## Parts Bulletin

### Fuse/Relay box replaced

**Models: gas 4.3/S.0/S.7/8.1L    EFI**

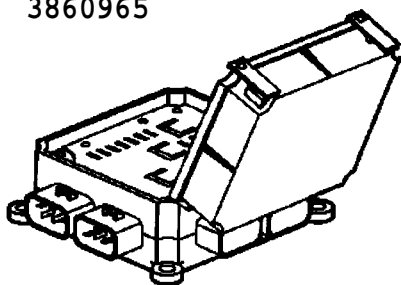
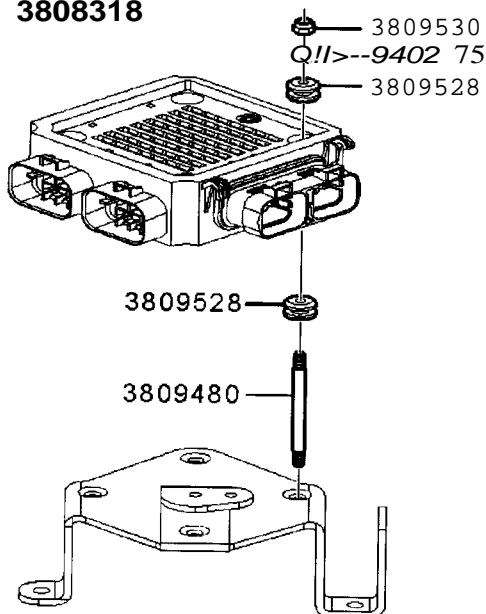
The following fuse/relay box part numbers have been replaced by service kit **3808318**;

These boxes, shown at left, were used on the following gas EFI engines;

4.3/5.0/5.7l spec numbers between 3869132 and 3869277.

8.1l spec numbers between 3869087 and 3869292.

Kit **3808318** contains the latest version of the fuse/relay box **plus** isolator bushings for mounting the box to the engine.

The isolators reduce vibration to the box, lengthening the service life of the box. Mounting instructions are included in the kit.

Part numbers for the isolators and hardware are shown in the illustration.
